802.3cg D3.1 Comments 90 & 91: Precision Time Protocol(PTP) and Half-Duplex

Peter Jones – Cisco

802.3cg D3.1 comments #90 & #91

Figure 148-2-PLCA functions within the Reconciliation Sublayer (RS)

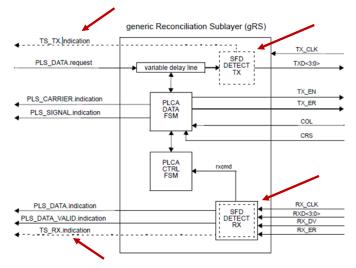
1 0 1	the network latency measurement is not affected by the	This change would introduce new functionality into the				
								synchronization latency added by PLCA. No special attention is	draft beyond the existing text or approved project				
91	Jones, Peter	148	148.4.2	235	10 T	ÎR 🛛	precision time support.	required for SFD detection of received frames."	objectives.	X	W	TSSI

Modify "Figure 148-2--PLCA functions within the Reconciliation Sublayer (RS)" to add TS_TX.indication, TS_RX.indication, SFD DETECT TX and SFD DETECT RX as shown in D2.0 Figure 148-3.

When TSSI is supported, transmit SFD detection occurs after the PLCA variable delay line, as shown in Figure 148-2. Clause 90 defines TS_TX.indication (90.4.3.1) and TS_RX.indication (90.4.3.2). Clause 90 also defines TS_SFD_Detect_TX (90.5.1) and TS_SFD_Detect_RX(90.5.2), these are shown in Figure 148-2 as SFD DETECT TX and SFD DETECT RX respectively.

148.4.2.1 Operation with TSSI

When TSSI is supported, transmit SFD detection occurs after the PLCA variable delay line, as shown in Figure 148-2.

Clause 90 defines TS_TX.indication (90.4.3.1) and TS_RX.indication (90.4.3.2). Clause 90 also defines TS_SFD_Detect_TX (90.5.1) and TS_SFD_Detect_RX(90.5.2), these are shown in Figure 148-2 as SFD DETECT TX and SFD DETECT RX respectively.
